CHANGE ORDER

Project Title Overhaul Base Apron Rehabilitation - Phase II

Change Order No: 1 Date of Issuance: 10-Oct-22

Change Order No. 1 issued to incorporate the attached P-156 Substitution Request, P-219 Substitution Request, RFP No. 1 and RFP No. 2.

SITE PLAN - 1 OF 5	
design MCG	CAD File: 2-62200517C19.DWG
drawn SML	Aviation Project No. 62210547
dwg date 04-01-21	dwg. no. C25 26 of 45

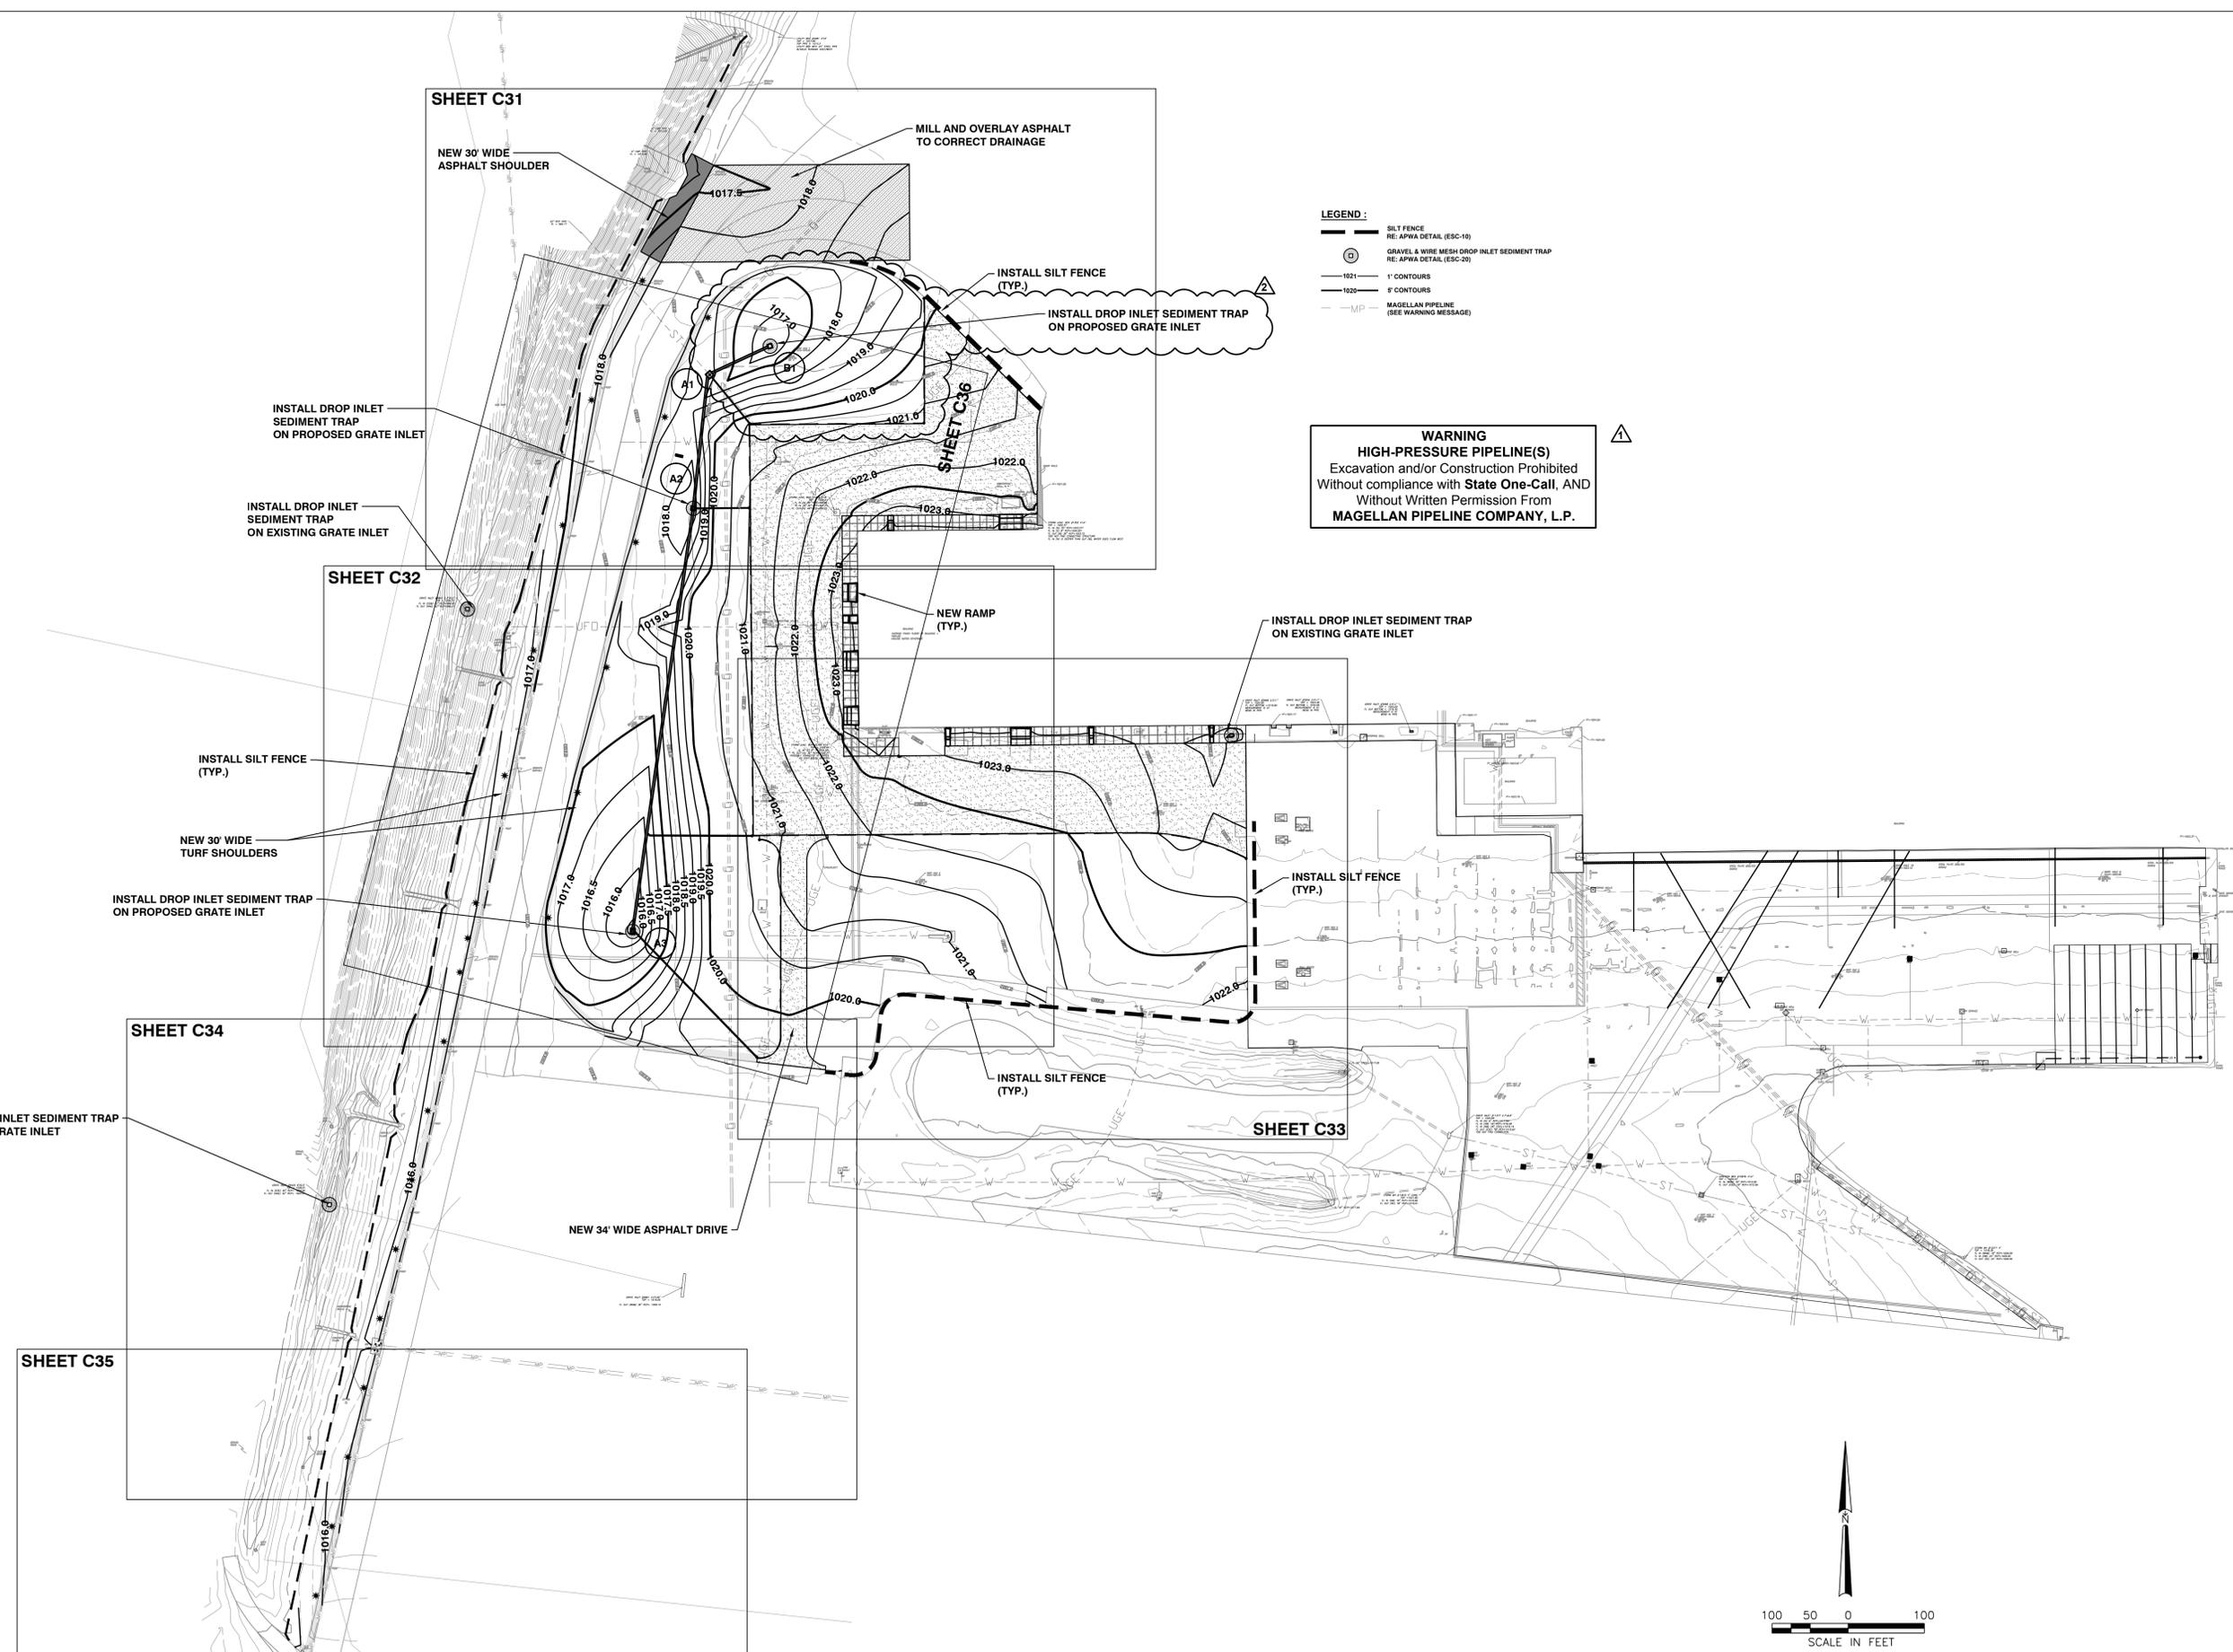
Please provide a new lump sum (LS) price to address the transition period between the regrading of this area until the drainage components (pipes and drainage structures) are installed to drain this area including all labor, materials, equipment and incidentals necessary to prevent the runoff of water/silt from this area across Taxilane C5.
